Infonote

AO-IN-2026-029-I

Introduction of improved carrier tape for Chip LED product family

Description of change:

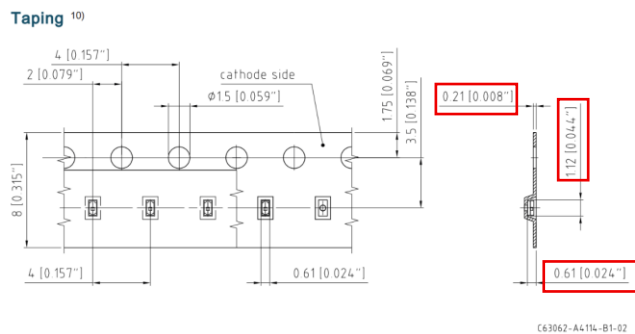
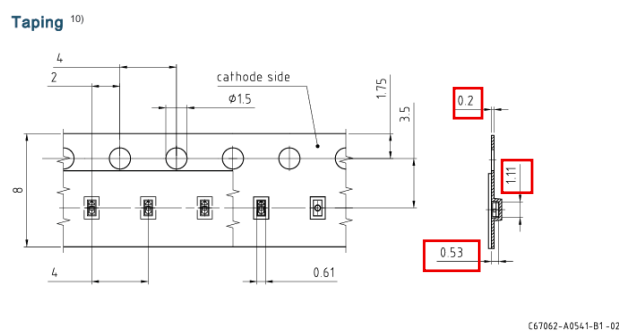
Objective:	Introduction of improved carrier tape for Chip LED product family
Affected products:	SFH 4043, SFH 4043B, SFH 4053, SFH 4053B
Reason for change:	Introduction of improved carrier tape design to reduce risk of slanting in tape: slight reduction of pocket size.

Time Schedule:	Implementation of improved carrier tape: SFH 4043 / SFH 4053: CW 24 / 2026 SFH 4043B / SFH 4053B: CW 21 / 2026
Assessment:	There is no change of the affected LEDs. No change in carrier tape material or other dimensions of the taping.
Documentation:	The tape drawing in the datasheet is updated accordingly. The inch values are removed from the drawing.
